TOLERANCE	Decimal ±0.2	DATE 2023. 06. 21.			 RF & MICROWAVE TECHNOLOGY Tel : 82-32-347-8015 Fax : 82-32-347-8017	
	Angle ±1°	APPROVED BY				
MATERIAL _____		CHECKED BY	TITLE SMA50 CABLE PL Fujikura 1.5D-HQEW			
		DRAWN BY				S.H.KIM
FINISH _____		SCALE 4/1	UNIT mm		A4	DWG NO. CN01092-7/3
						REVISION 1

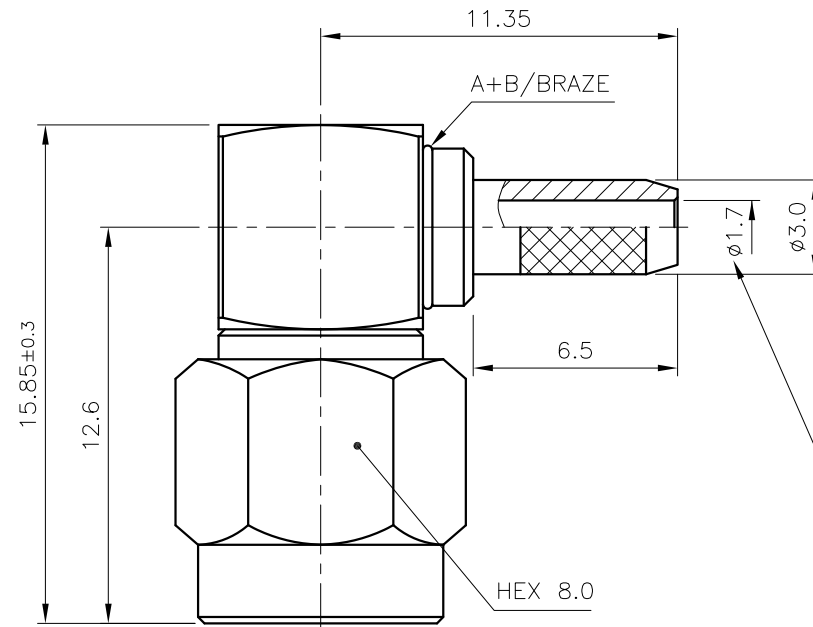
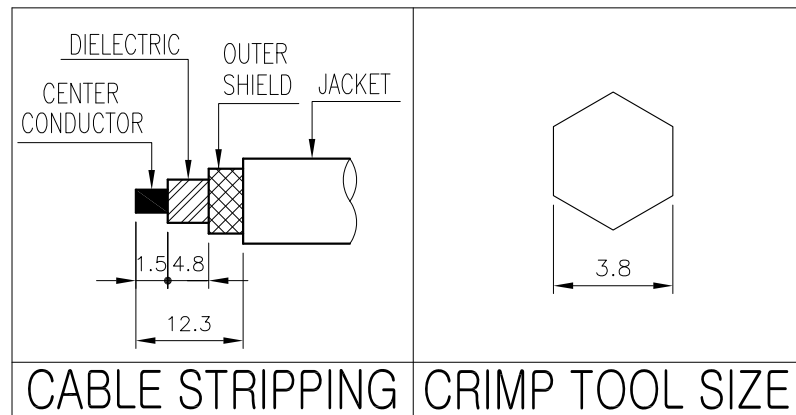
REVISION				
REV	DESCRIPTION	DRAWN	APPR	DATE
IR	Initial Registration	I.C.KIM		2018.08.09.
i	바디 A+B 억지끼움 후 용접으로 치수 공차 변경	S.H.KIM		2023.06.21.

하이스핀 Ø1.7 삽입하여 전수 검사 할 것
(BODY 간 내부 은땜 흐름 및 뭍침 여부 확인)
